ECQ method

(comment R2-205 and others)

Comment R2-205

Proposed text for 180.9.6

Figure 180–10—Illustration of the TDECQ measurement

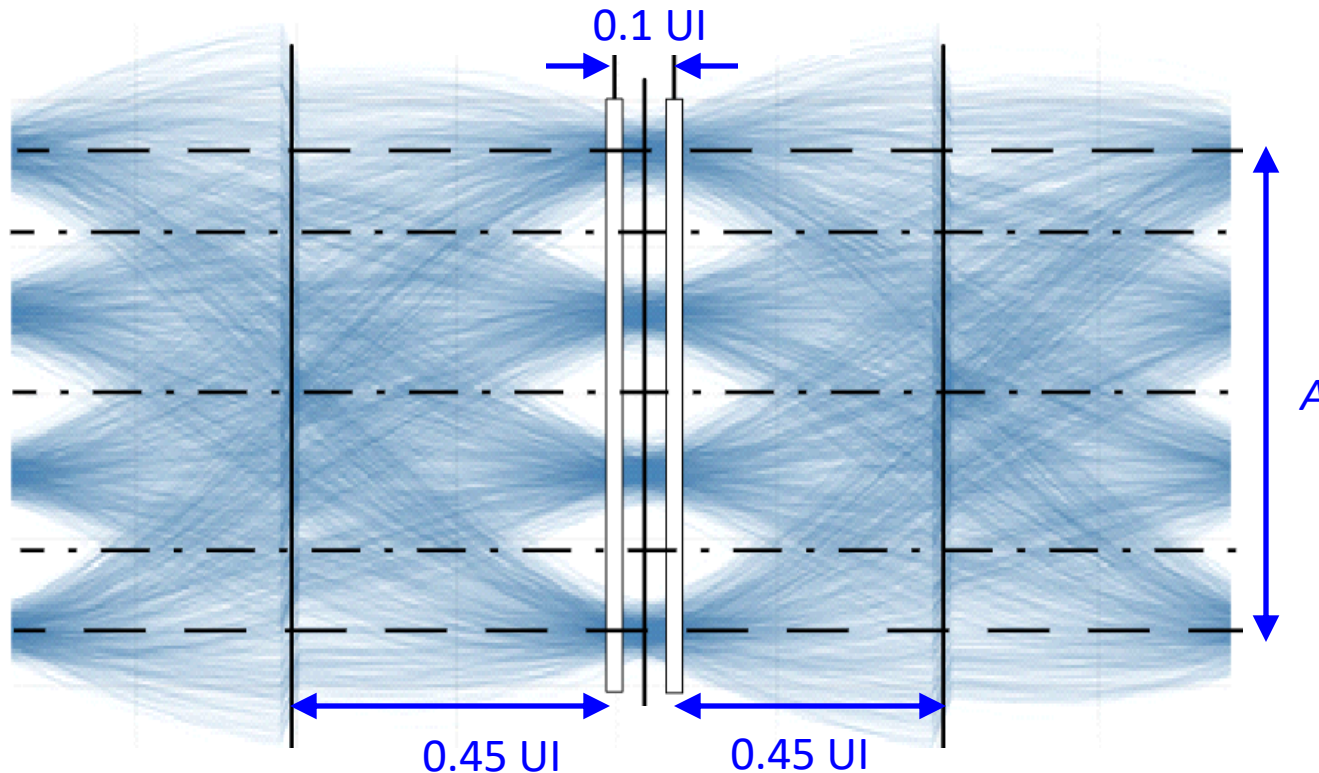
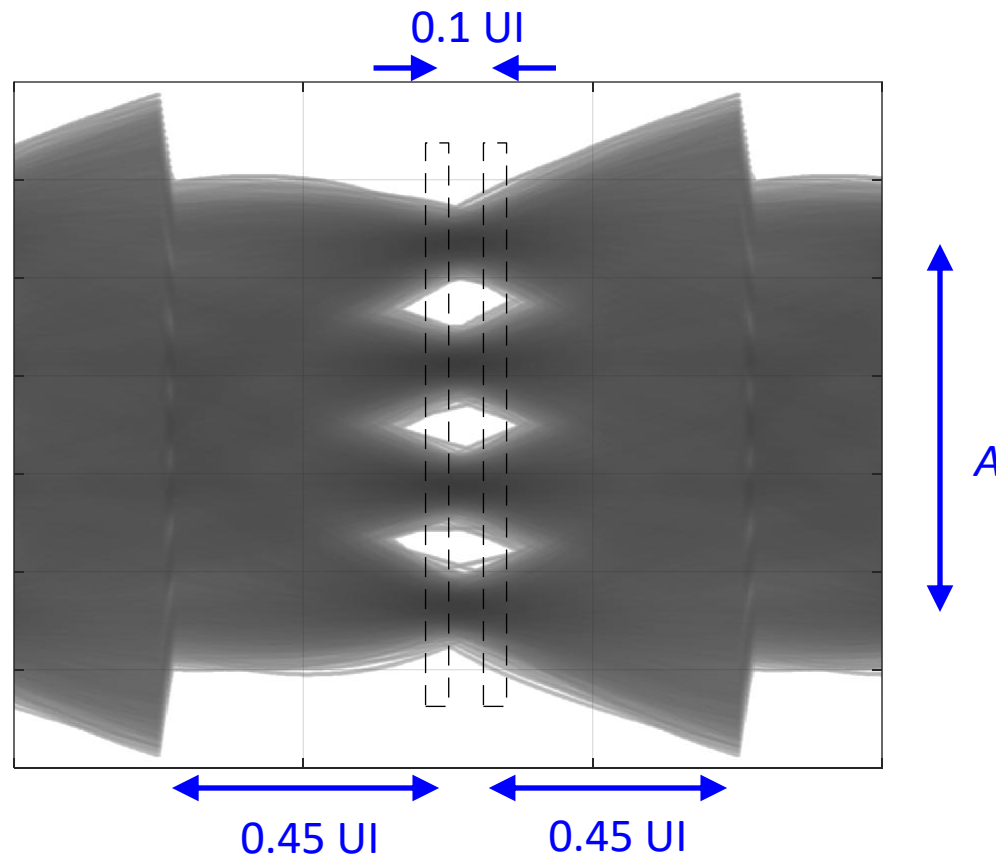
- If available, replace the graphic with one with the correct histogram window widths, transparent histogram windows, without the three vertical lines, and with the feedback transitions at 180° from the histograms, as illustrated on the next slide
- No need to label the horizontal lines, which could be left out too

Figure 180–11—TDECQ reference equalizer functional model

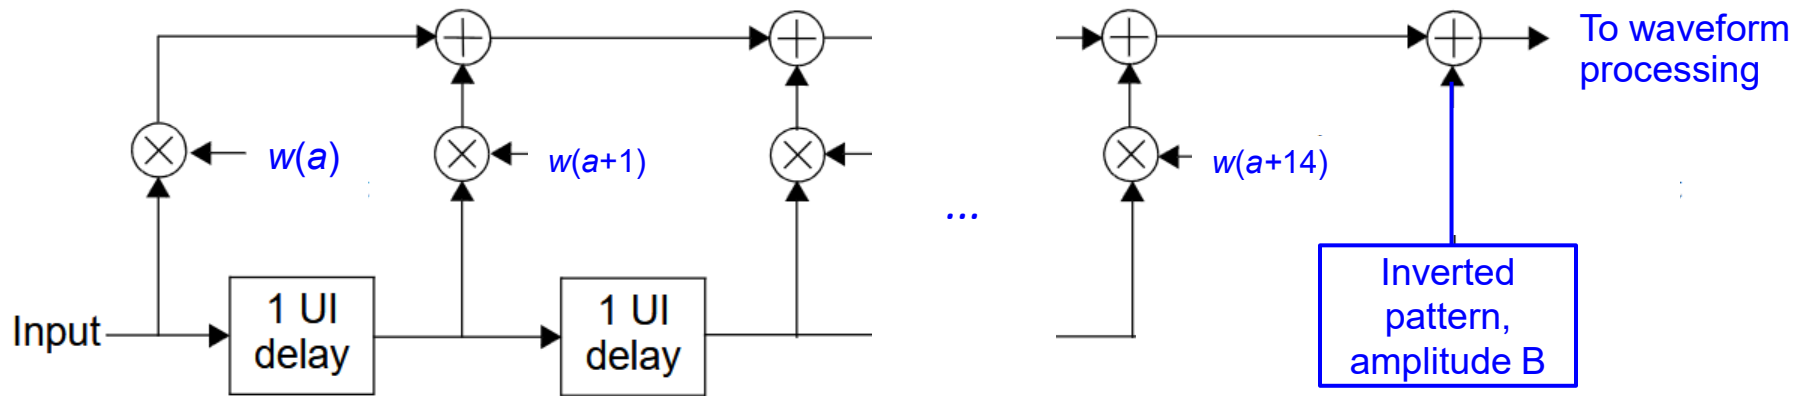
The reference equalizer has 15 T -spaced feed-forward taps, where T is the symbol period, and a pattern generator representing a single decision feedback tap. This feedback pattern is an inverted and level-shifted copy of the test pattern, with timing representing feedback from the previous unit interval. It is added as a high bandwidth signal with levels $-B/2$, $-B/6$, $B/6$, and $B/2$, changing value 0.5 UI after the mean timing of the histogram windows, as shown in Figure 180–10. The peak-to-peak amplitude B is to be optimised along with other tap coefficients, the three thresholds, and the timing of the pair of histogram windows, subject to the limit for $b(1)$, where $b(1) = B/A$. A functional model of the reference equalizer is shown in Figure 180–11; the reference equalizer tap coefficients are specified in Table 180–16.

Figure 180–10—Illustration of the TDECO measurement

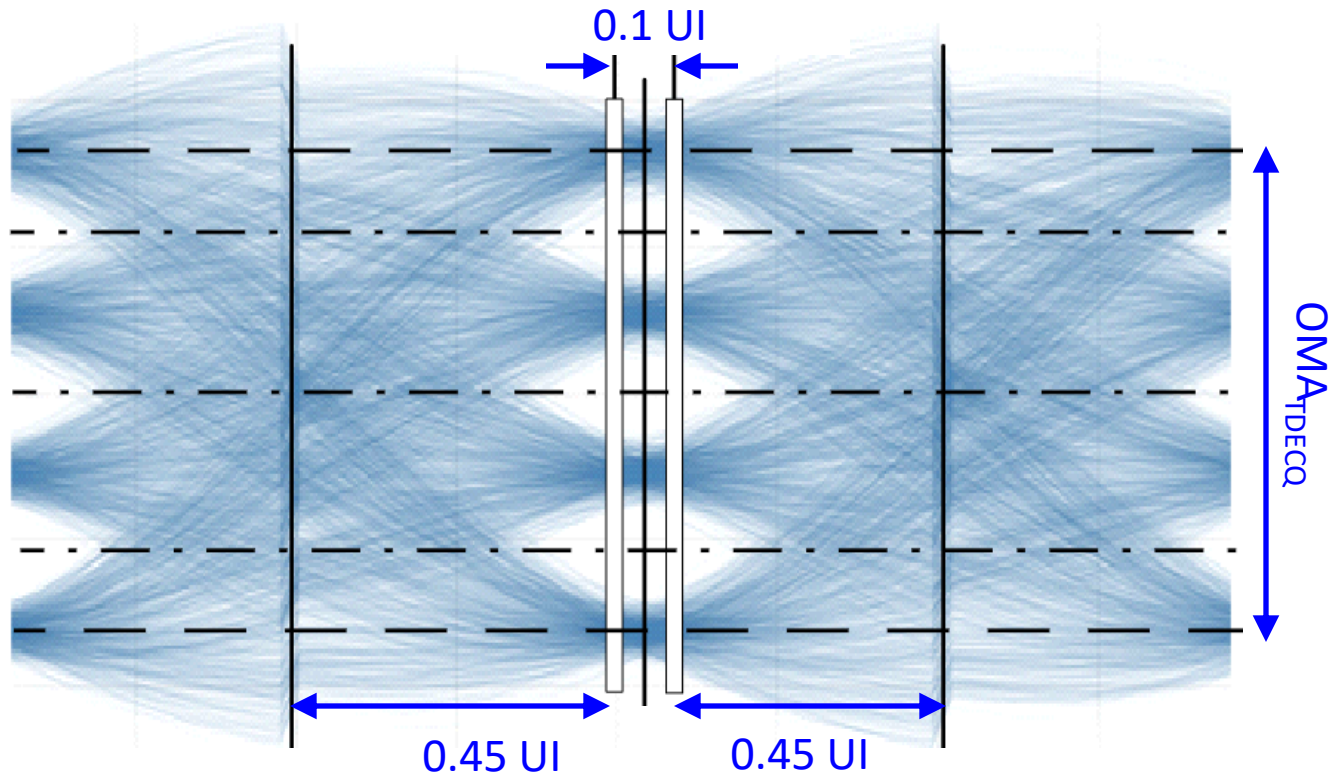
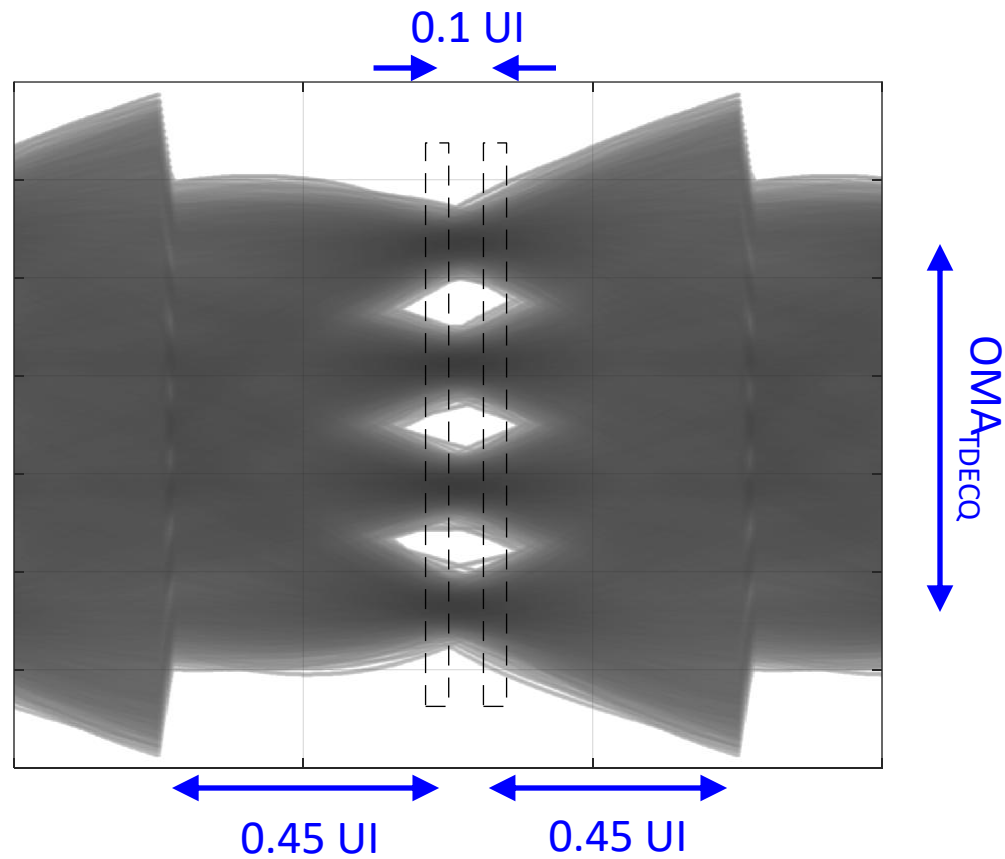
- If available, replace the graphic with one with the correct histogram window widths, transparent histogram windows, without the three vertical lines, and with the feedback transitions at 180° from the histograms, as illustrated on the next slide
- No need to label the horizontal lines, which could be left out too
